N1922A-01A

S E R V I C E N O T E

Agilent P-series Wideband Power Sensor

Loose bulkhead (N1920-60005)

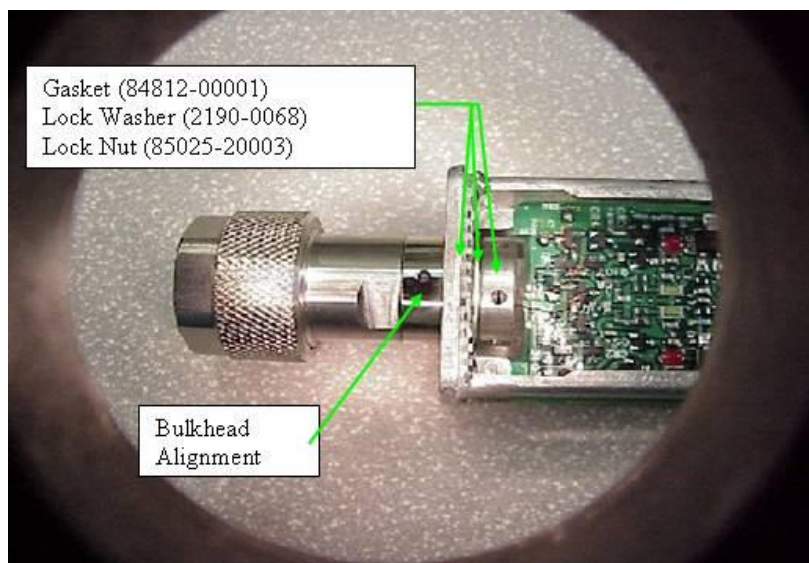
Loose bulkhead (p/n: N1920-60005) for P-series wideband power sensor built in US. Kindly send it to local service center for rework.

1. Screw lock nut 85025-20003 onto threaded end of bulkhead assembly. Apply loctite (0427-0231) on the first, second and third threads of the end of the bulkhead (as shown in the figure below):

2. Torque lock nut to 28 in. -lbs. with T-314592.

3. Calibrate the unit after the above changes are applied.
